HISTORIC AND DESIGN REVIEW COMMISSION

HDRC CASE NO:	2017-D03
ADDRESS:	303 Blum, 207 and 224 Elm St, and 1001 E Commerce St
LEGAL DESCRIPTION:	Lots 90 and 91, Block 3, NCB 153
ZONING:	D AHOD
PUBLIC PROPERTY:	No
COUNCIL DISTRICT:	1
DISTRICT:	Downtown Business District
LANDMARK:	No
APPLICANT:	Jennifer Heiney, Epstein Global
OWNER:	BRE/LQ TX Properties, LP
TYPE OF WORK:	Façade improvements

The applicant requests a Certificate of Appropriateness for approval to: update the entire building façade including the porte cochere and roof, as shown in the attached Exhibits A, B, and C.

EXHIBIT B

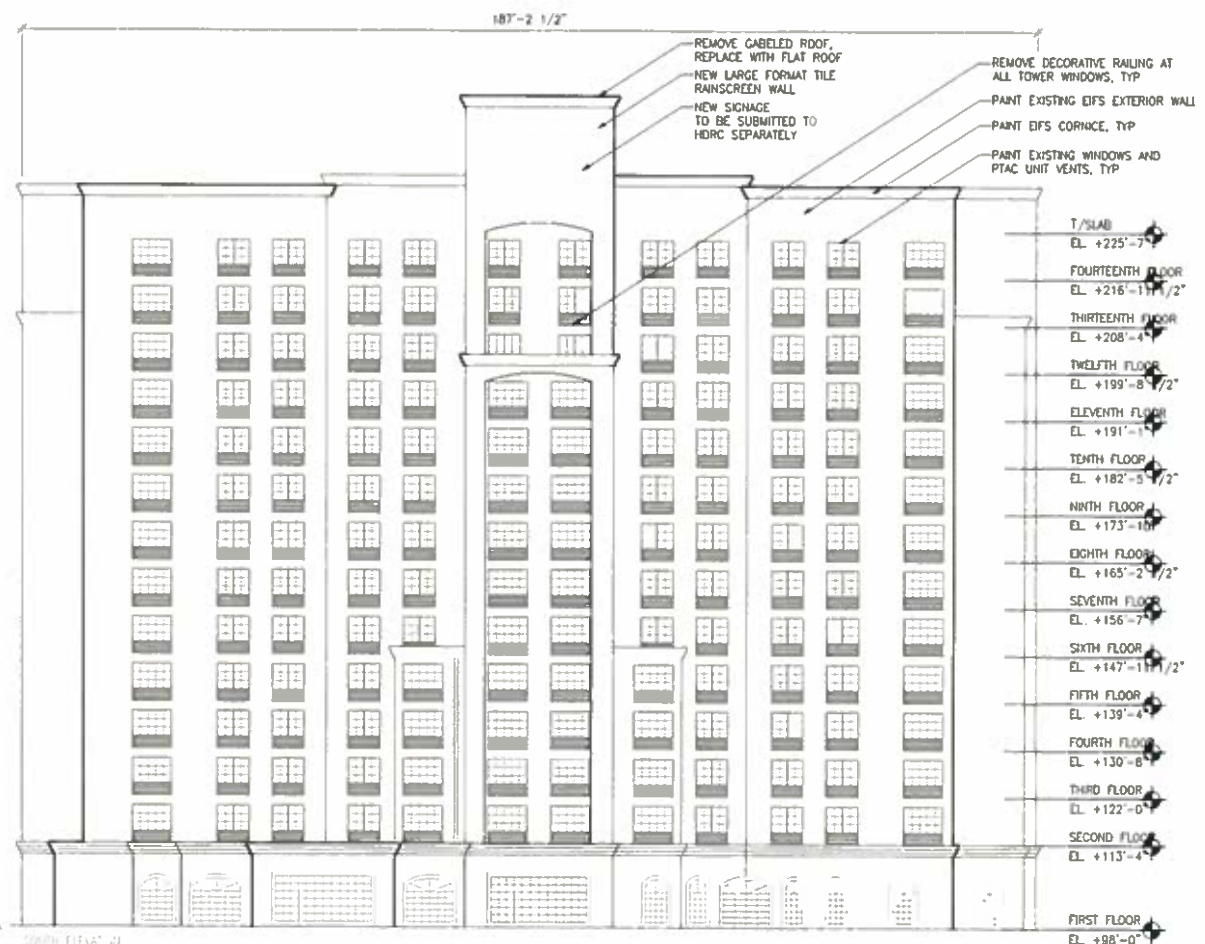
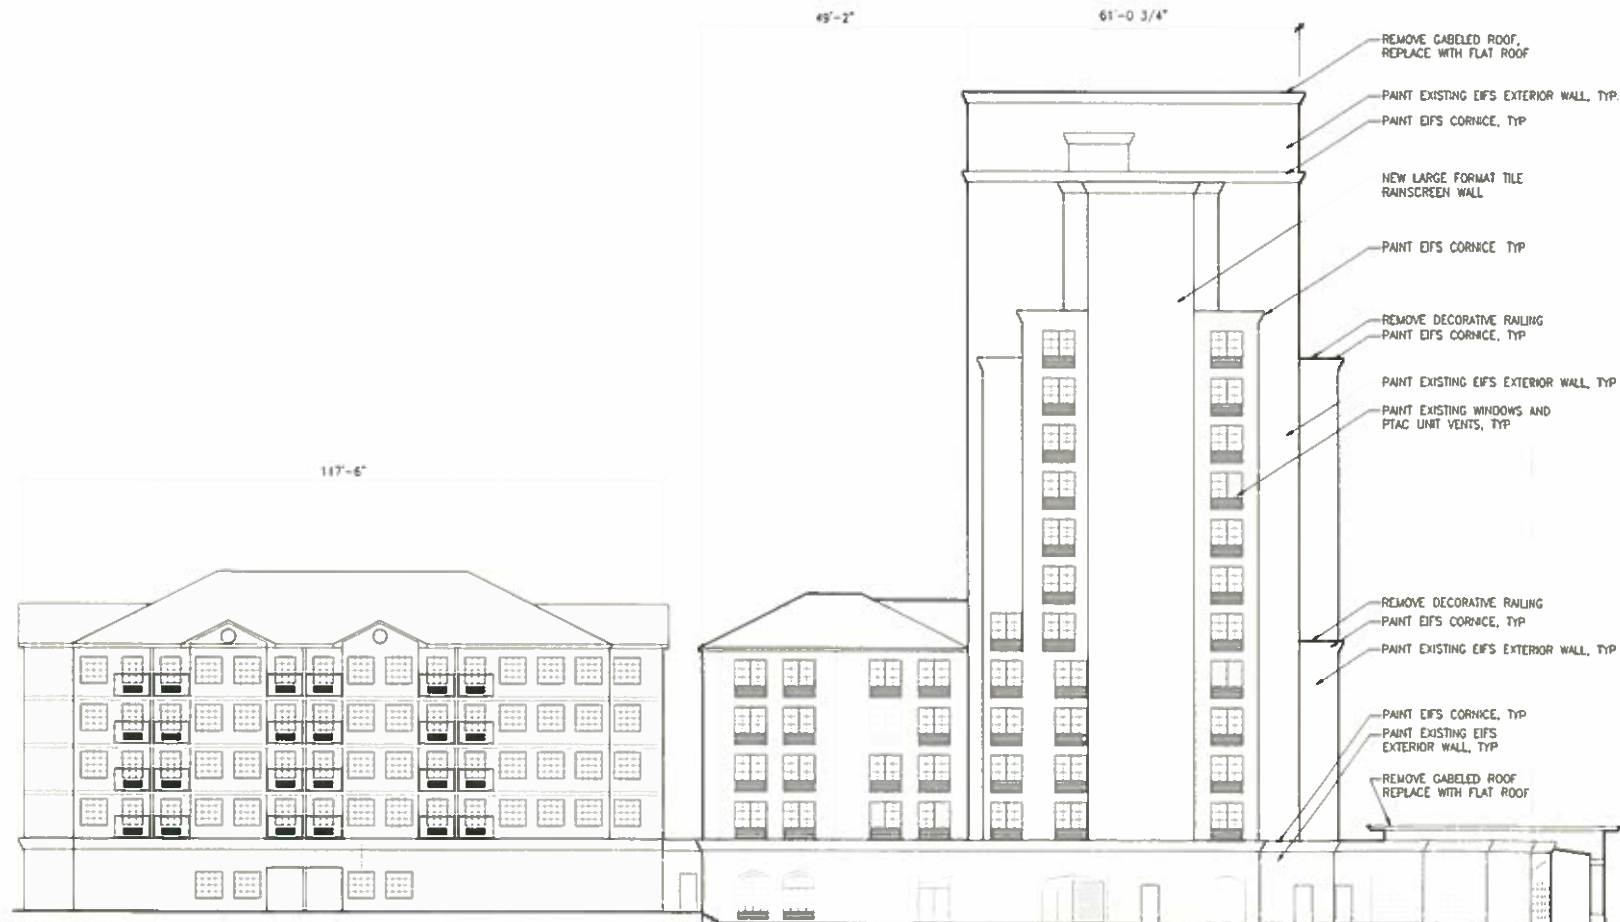
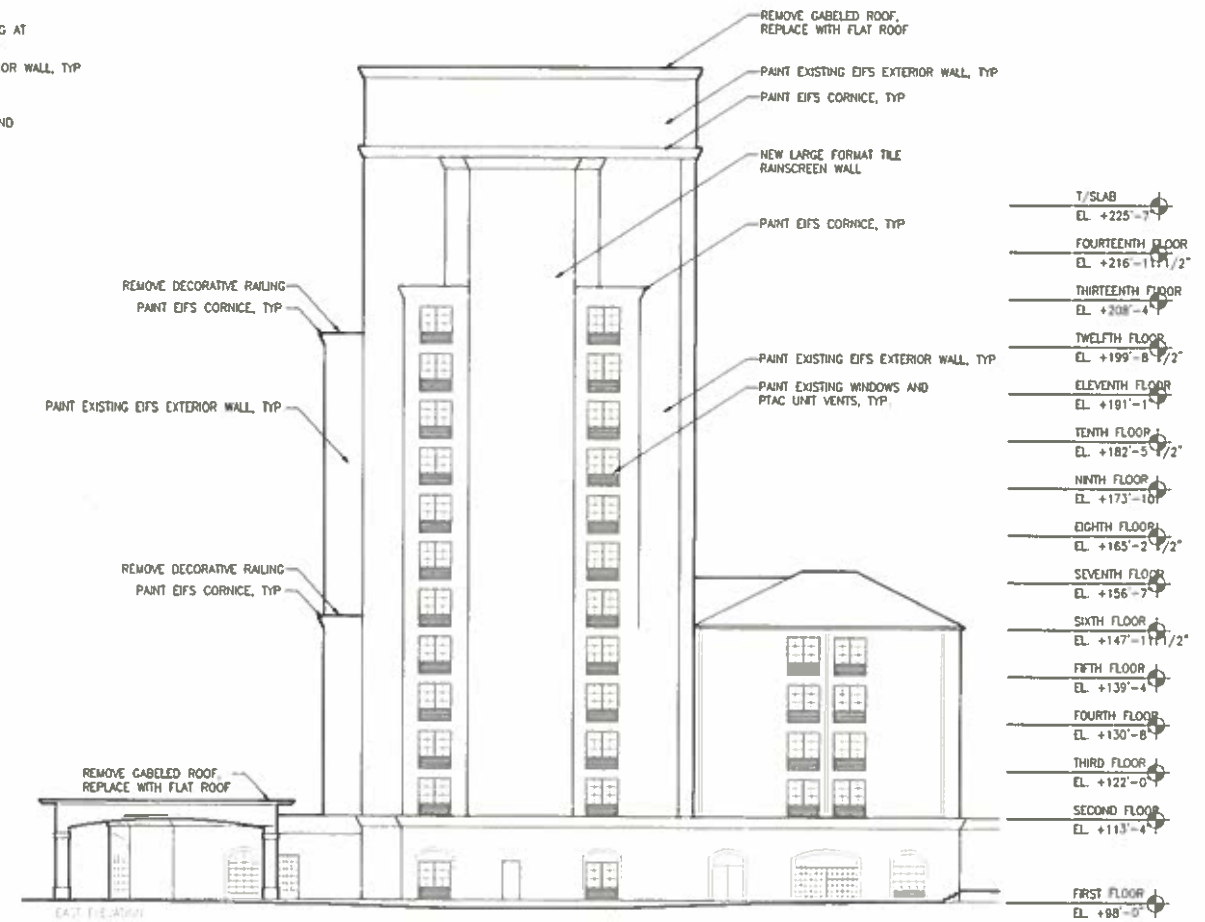
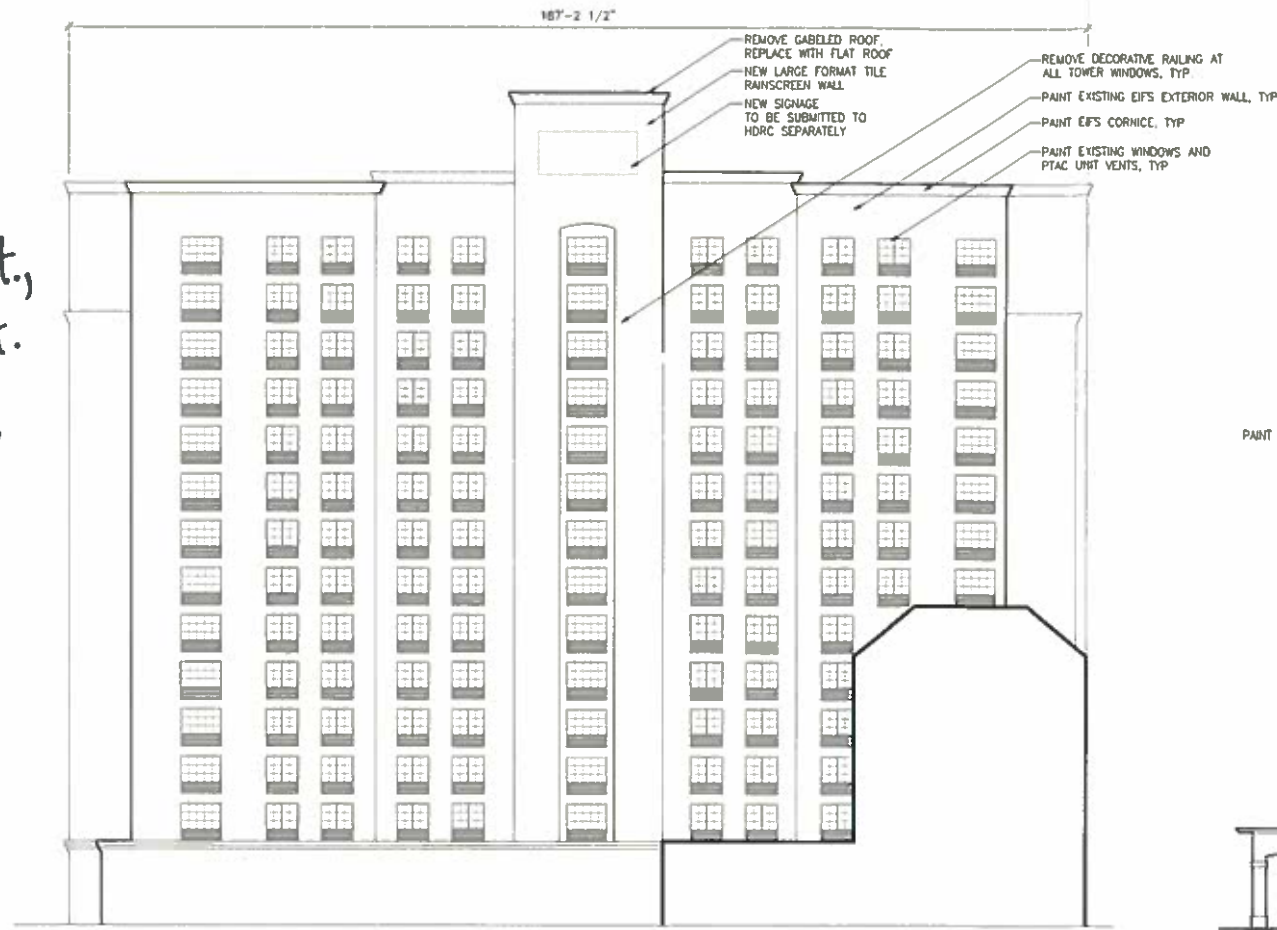
Although the proposed façade improvements include EIFS (exterior insulation finishing systems) which are prohibited by the Downtown Design Guide (DDG) design standards, the material is existing and predates the adoption of the DDG and therefore is legally nonconforming. The existing EIFS is not being replaced, only repaired and repainted. Where EIFS is removed, it will be replaced with neolith panels/tiles that are permitted by the DDG.

Staff recommends approval as submitted, as shown in the attached **Exhibits A, B, and C**.
